| Model: <b>MT-C6</b> | Date: 30-May-16 | No.: RD223005 |

| Subject: Firmware Release Note: Inserter_CFEEDER_E           |  | Prepared by: K. Moriizumi                            |  |
| From: 1st Tech Service Sect., MFP/Printer Tech Service Dept. |  |  |  |

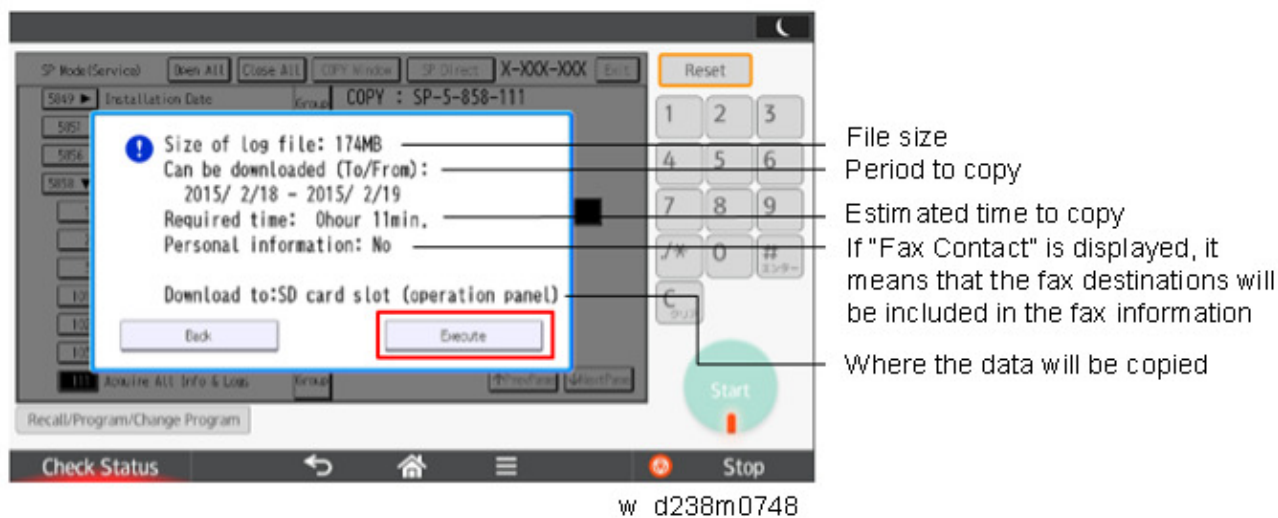
Log capturing information was corrected and added in ***red*** in the following section of the Service Manual:

• “2” is set by default, which is the minimum needed for investigating the problem.

• A value of “1” to “180” can be set.

6. Execute SP 5-858-111 (Acquire All info & Logs) to copy all of the log types to an SD card. It is possible to obtain the logs separately by the following SPs.

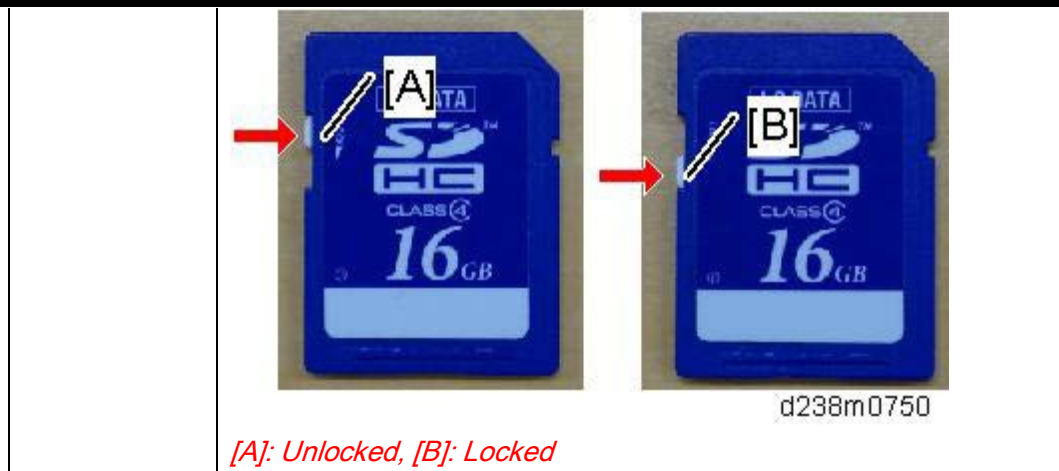
*Transfer time may be affected by the type or format of the SD card.* The approximate time required for the transfer of the following debug logs are:

- Controller *device log* (GW *device log*): 2 to 20 min.
- Engine debug *device log*: 2 min.
- Operation *panel device log*: 2 to 20 min.

### Accessory Check

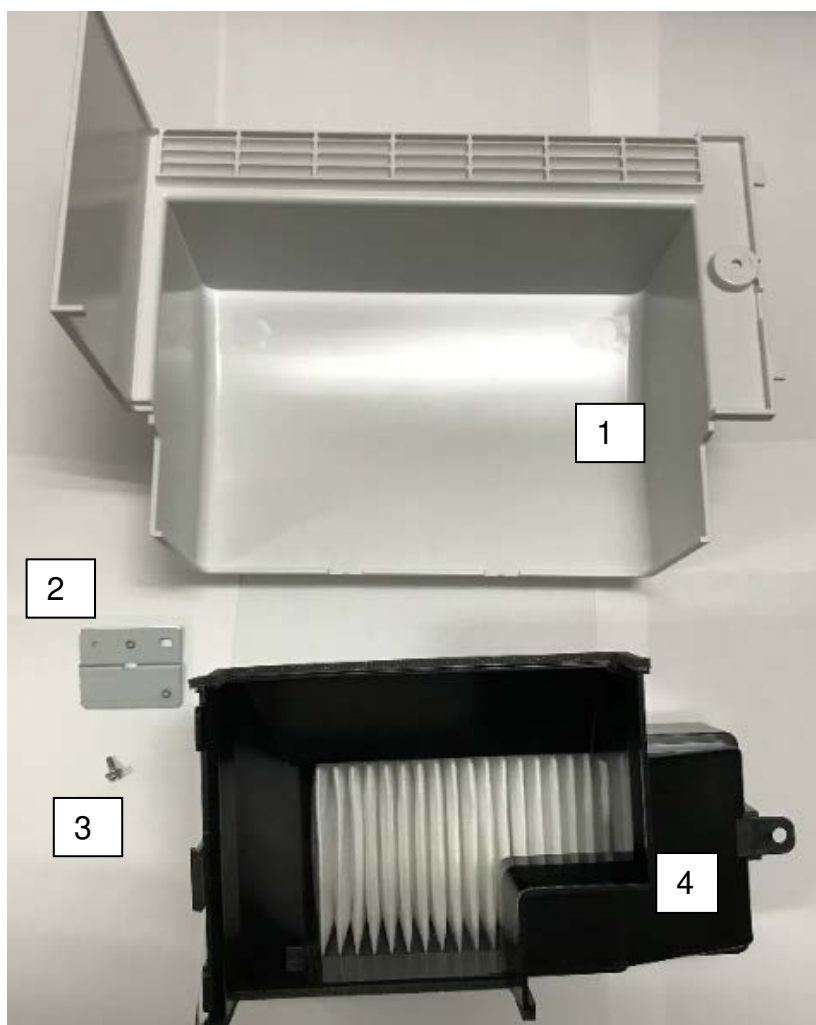
The extra filter unit has been added to match the new BAM regulation for European models.

The additional accessories inside of the tray 1 as below.

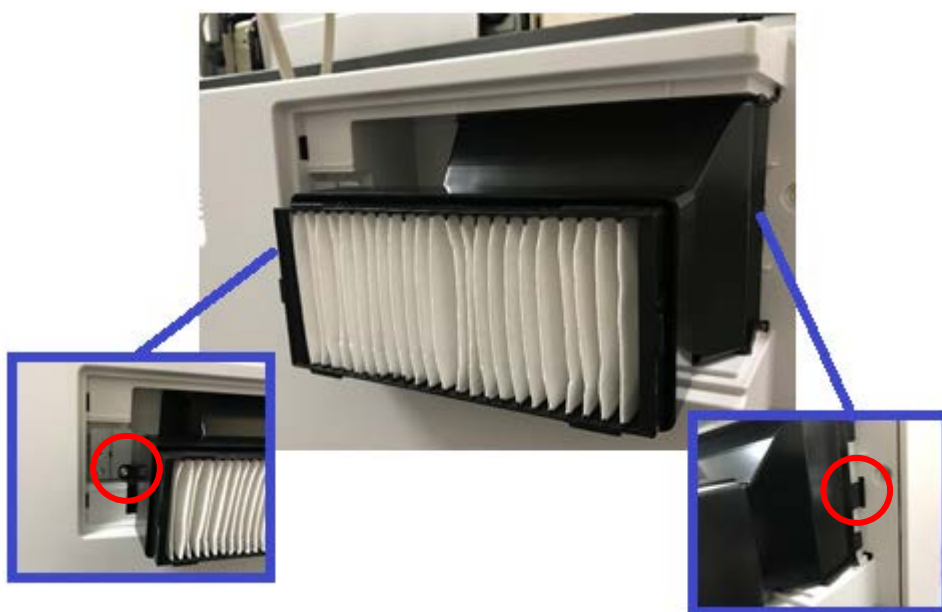
1. Remove the filter cover. (2 screws)

2. Attach the screw bracket (1 screw).

3. Attach the extra filter unit. (1 screw and 1 hook)

4. Attach the extra filter cover. (2 screw)

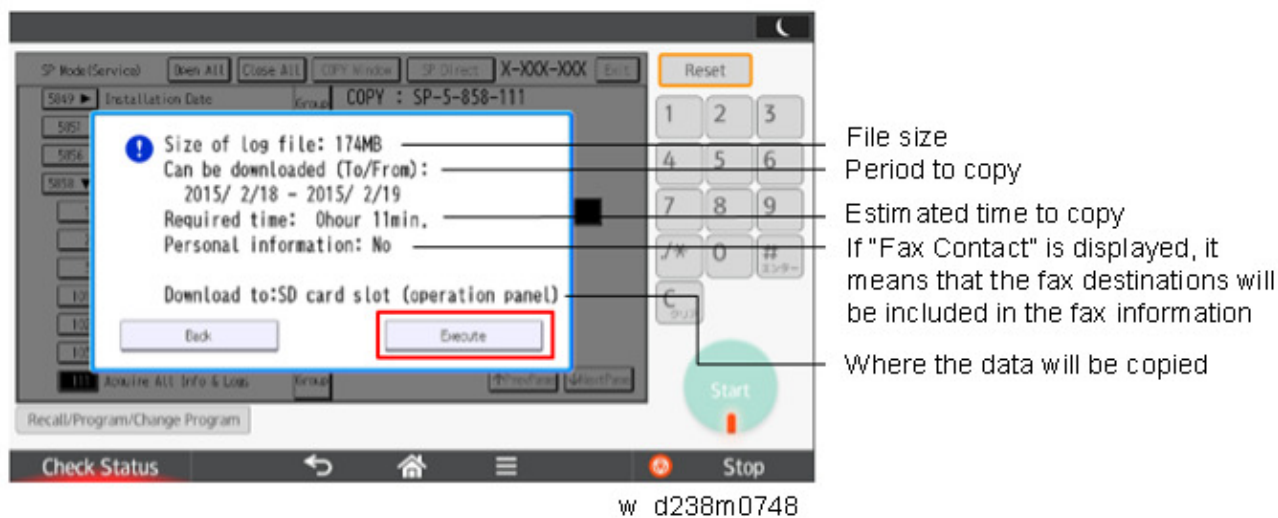
Log capturing information was corrected and added in ***red*** in the following section of the Service Manual:

• “2” is set by default, which is the minimum needed for investigating the problem.

• A value of “1” to “180” can be set.

6. Execute SP 5-858-111 (Acquire All info & Logs) to copy all of the log types to an SD card. It is possible to obtain the logs separately by the following SPs.

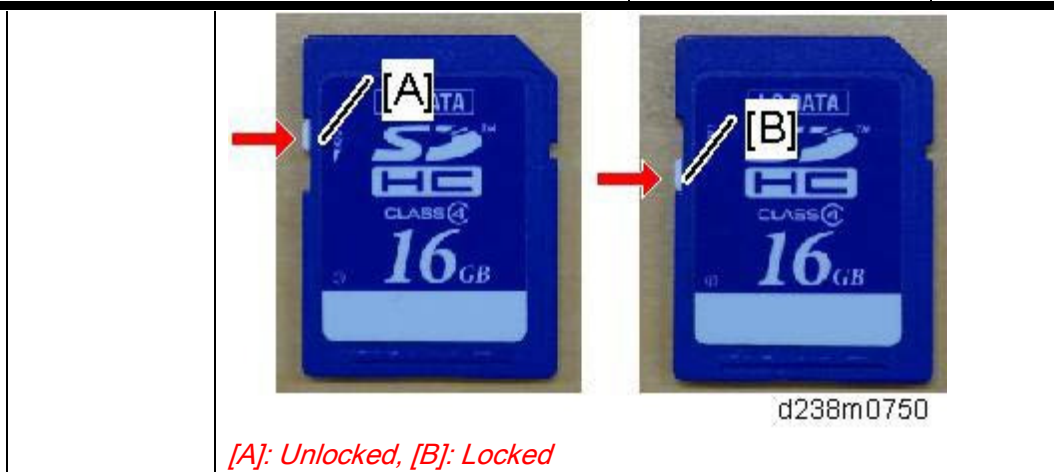
*Transfer time may be affected by the type or format of the SD card.* The approximate time required for the transfer of the following debug logs are:

- Controller *device log* (GW *device log*): 2 to 20 min.
- Engine debug *device log*: 2 min.
- Operation *panel device log*: 2 to 20 min.

## Accessory Check

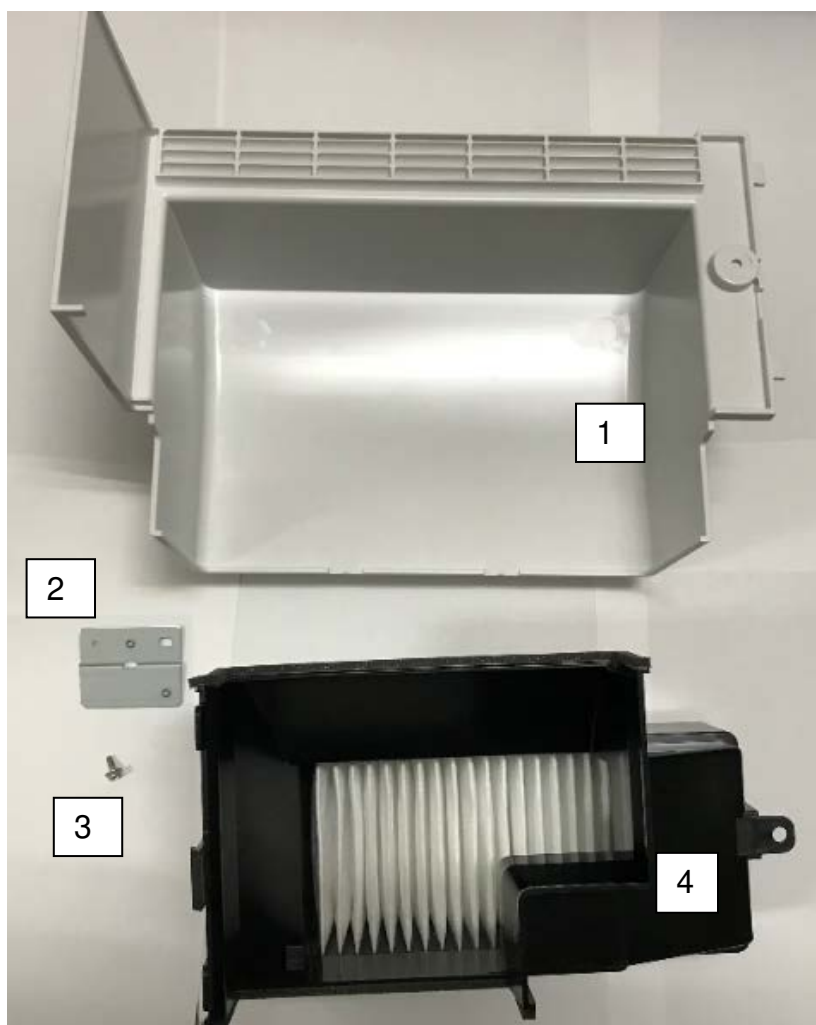
The extra filter unit has been added to match the new BAM regulation for European models.

The additional accessories inside of the tray 1 as below.
